Third Five-Year Review Report

Queen City Farms Superfund Site

City of Maple Valley
King County, Washington

September 2008

Figure 9: Lower Aquifer 2 – Average TCE Concentrations (July 2007- June 2008)

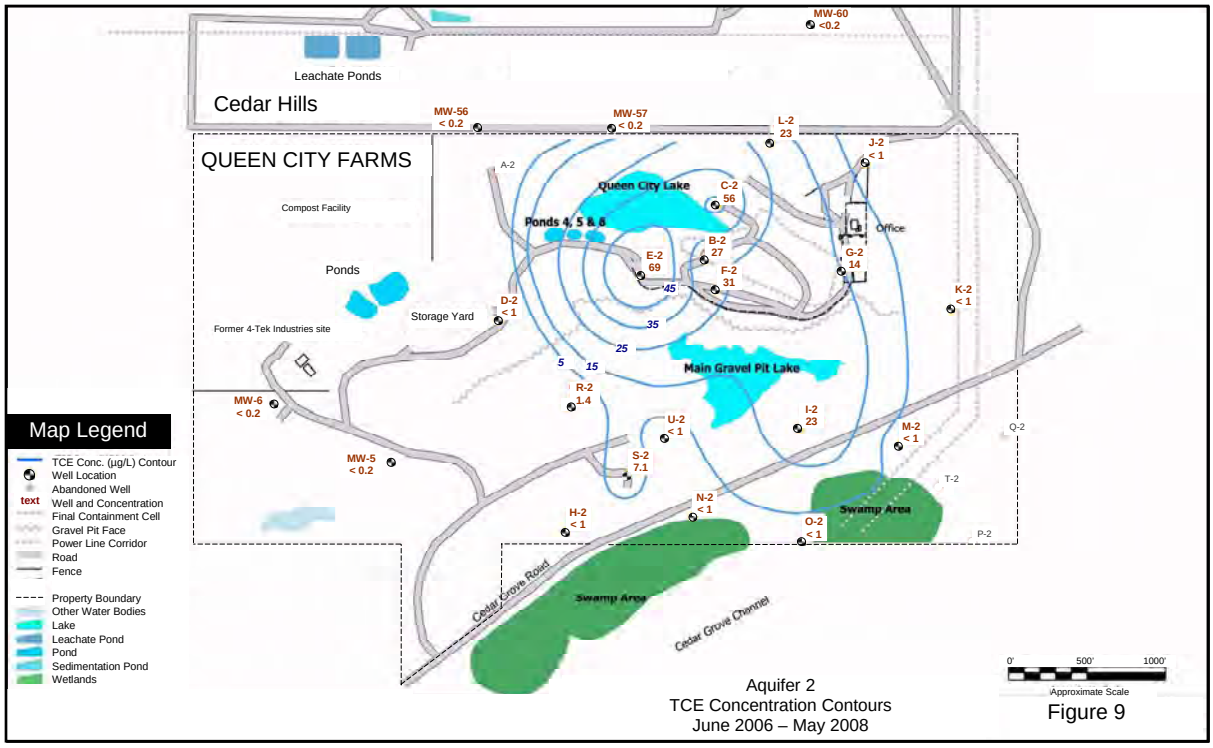
has been effectively stopped; however, contamination in upper Aquifer 2 has been discovered to extend further north than was recognized in the ROD. Overall, TCE mass in the Aquifer 2 plume has been declining. However, since the last five-year review, TCE levels in the southwestern corner of the lower Aquifer 2 plume have increased from barely detectable to above the MCL and are currently at 8.4 µg/L in well S-2, suggesting instability in that area of the plume. (See Figure 9.)

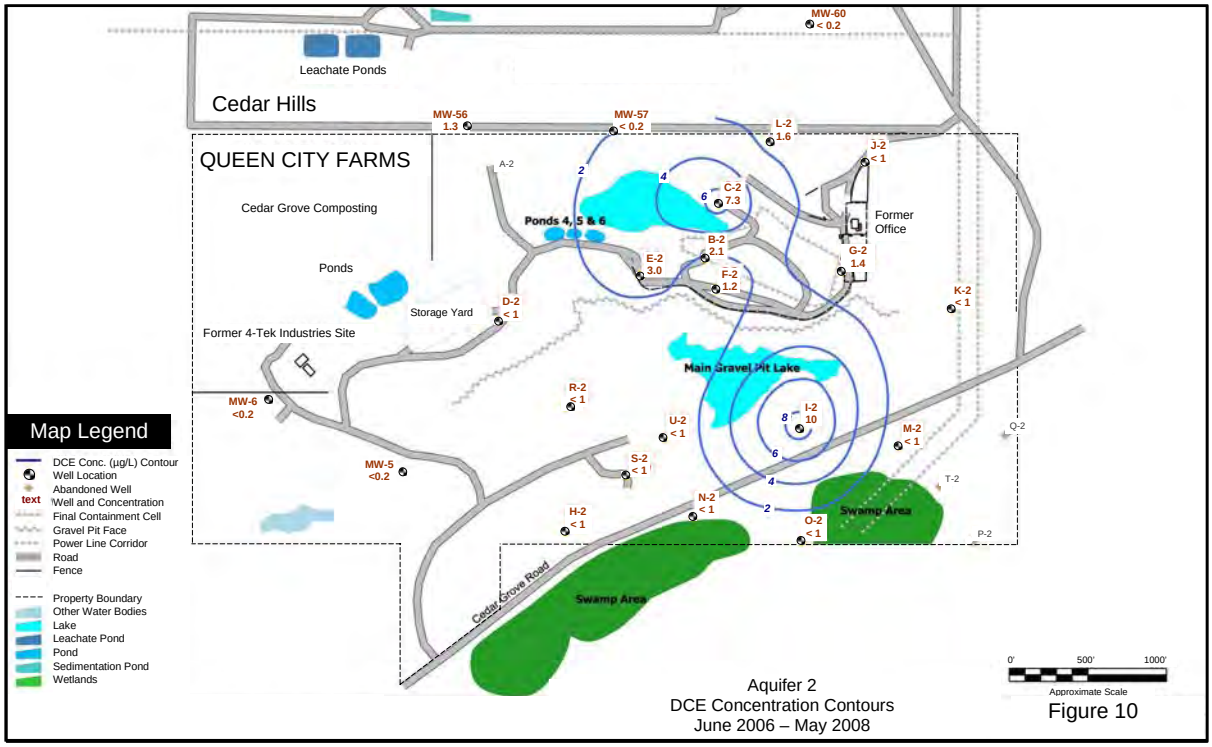
[24] Although the current monitoring well network has wells to the northeast of E-2 (Wells C-2 and L-2) and a well west of E-2 (Well D-2), it does not have any monitoring wells located in between those points. See Figures 9-10 in Appendix 1 for more detail.

- Demonstrate plume containment or take action to contain the groundwater plume.
- Demonstrate sufficiency of the monitoring network or add additional wells to make it adequate.
- Implement either the contingent pump and treat action or an equally effective alternate method
- Evaluate monitoring Aquifer 3 groundwater for geochemical and conventional groundwater parameters.
